**ARBORIST REPORT**  
**for**  
**WW Sustainable LLC**  
**4657 86<sup>th</sup> Ave SE**  
**Mercer Island, WA**

October 10, 2022  
**UPDATED MARCH 17, 2023**

# Memorandum

To: Cam Weaver  
Company: Weaver Construction Co.  
From: Benjamin Mark – Salish Restoration Associates  
Date: 3/21/23  
Re: Planned Excavation Within Driplines of Retained Trees

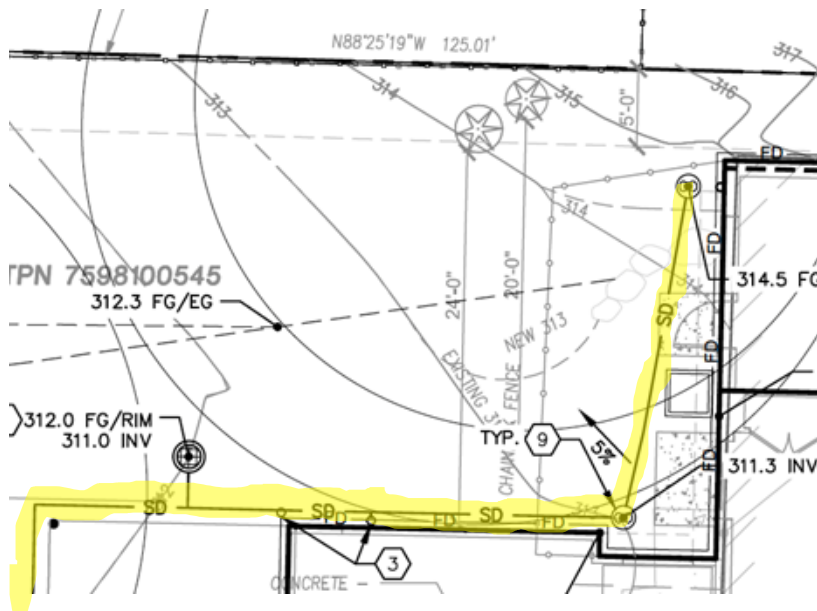
The Planning Department comments dated Feb 16<sup>th</sup>, 2023 included the following from City Arborist John Kenney:

1. Trees 4,5, 9,10 are exceptional and must be protected and not damaged. Tree protection is only 3' away from tree 10 which would damage the tree. Either move the proposed ADU, decks, buried power, all grading and SD utility line away from these trees. Any encroachment into these trees' dripline must show the trees will not be damaged according to MICC19.10.080. Or advanced root analysis by air excavation with arborist monitoring and follow up analysis required. The arborist will determine the limits of allowable disturbance for the trees where tree protection fence will be placed and not moved. At least 5 feet of space between the building and the fence is required to construct the home without entering the tree protection zone. Arborist must review and cite the civil and site plans. Or if trees cannot be retained and undamaged, they must be justified for removal under MICC19.10.060(A)(3).

The northwest corner of the existing house is within the dripline of Tree #10, approximately 12 feet from the trunk. If a minimum of five feet of space between the building and the tree protection fence is required, this will significantly reduce the area of undisturbed grade within the trees' critical root zone. Any encroachment into these trees' dripline must show the trees will not be damaged according to MICC19.10.080.

The current site plan shows a storm drain trench is planned to be installed within the shared drip line of Trees #9 and #10 west of the existing home's footprint. The route of this storm drain is within the required five-foot space between the existing building footprint and the tree protection fence.

Douglas-fir trees typically demonstrate relatively good tolerance of root pruning and are somewhat tolerant of fill placement. However, construction impacts, existing physiological defects, and site changes can combine to destabilize a tree.

Determining the size and number of roots that will be encountered during the installation of the storm drain requires an advanced root analysis by air excavation (Air-spade).

Air excavation of the drainage path will allow the project arborist to assess the potential impacts to trees #9 or #10 and potentially allow for installation of the storm drain below significant structural roots without cutting them.

If all structural roots over three-inches in diameter can be preserved, the tree's structural integrity is unlikely to be affected, but some decline in vigor may be seen in the future due to loss of roots within the 'Critical Root Zone' (CRZ) of these trees.

- Excavate the drainage path within the drip lines with an air-spade to allow the project arborist to assess the roots in the trench. If possible, install the drainage pipe below the structural roots without cutting them. Following excavation, supply supplemental irrigation to the trees until the fill can be replaced.
